Rampion 2 Offshore Wind Farm (Project Reference: EN010117)

Deadline 5 Submission (9 July 2024)

West Sussex County Council (IP Reference 200445228)

Screenshot from Figure 7.2.2h (B) Woodland retention plan in the OCoCP [REP4-043] indicating W3713 shaded blue defined in the key as 'retained'.

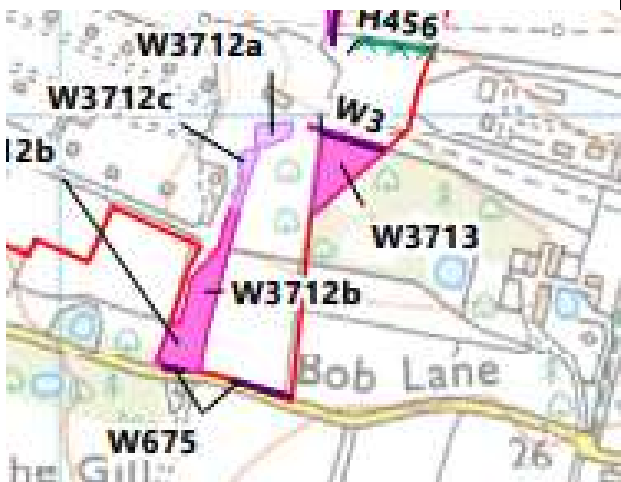
The Forestry Commission	<i>contrary to that stated within the Applicant's response, as well as plans shown within inset 45 of the Arboricultural Impacts Plan found within the Arboricultural Impact Assessment [APP-194], as well as what can be achieved within the indicative plan for the AIS extension option without adverse impact (as shown within the Design and Access Statement). [REP3-013]. Therefore West Sussex CC remains unsatisfied that the impact on deciduous woodland, a priority habitat, are at all clear at this location."</i>	
--	--------------------------------	--	--
